Access Compliance Report Public Rights-of-Way (Curb Ramps)

Intersection ID: 23563 Main Street: HILLSIDE_LN Cross Street: REA_RD Location: E

ADA ID: BFBD1F046EAC Ramp Type: PerpDiag Initial Pass/Fail: Fail Overall Compliance: No Severity Score: 37.5

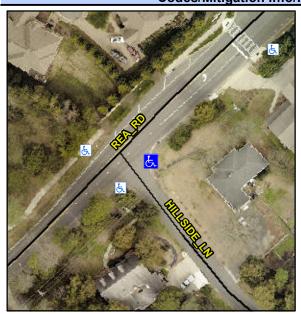
Not Found, R304.2.2, R304.5.3

Compliance Description Data Compliance Description Data No N/A Ramp Length (in) 60.0 Ramp Slope (%) 9.3 No Ramp XSlope (%) Yes Ramp Width (in) 48.0 8.1 N/A N/A Flare Type LT N/A Flare Type RT N/A N/A N/A Flare Slope RT (%) Flare Slope LT (%) N/A N/A N/A Flare Traversable LT? N/A N/A Flare Traversable RT? N/A N/A N/A N/A **DWS Provided?** N/A Landing Length (in) N/A Landing Width (in) N/A N/A **DWS Contrast?** N/A N/A N/A Landing Slope (%) N/A DWS Length (in) N/A N/A Landing X Slope (%) N/A N/A DWS Full Width? N/A N/A Landing Curb? (Y/N) N/A N/A DWS Offset (in) N/A N/A N/A Shared Landing? N/A Gutter Ponding? N/A N/A Gutter Slope (%) N/A N/A Gutter Lip Ht (in) N/A N/A Gutter X Slope (%) N/A N/A Painted X Walk1? No N/A Painted X Walk2? No X Walk 1 Direction To NW X Walk 2 Direction To SW N/A N/A X Walk 1 Width (in) X Walk 2 Width (in) N/A X Walk 1 Slope (%) 3.0 X Walk 2 Slope (%) 7.1 X Walk 2 X Slope (%) X Walk 1 X Slope (%) 7.0 1.1 N/A N/A N/A Ramp inside XWalk2? N/A Ramp inside XWalk1? Road Slope (%) 6.2 N/A Clear Space? N/A N/A Road X Slope (%) 5.4 Clear Space to XWalk (in) N/A N/A N/A Any Obstructions? N/A Storm Grate/Utility Hazard? N/A **Obstruction Type** Storm Grate/Utility Type N/A N/A Yes Surface Condition? (G/P) Good

Remove & Replace Curb Ramp With Two New Directional Ramps or Equivalent.
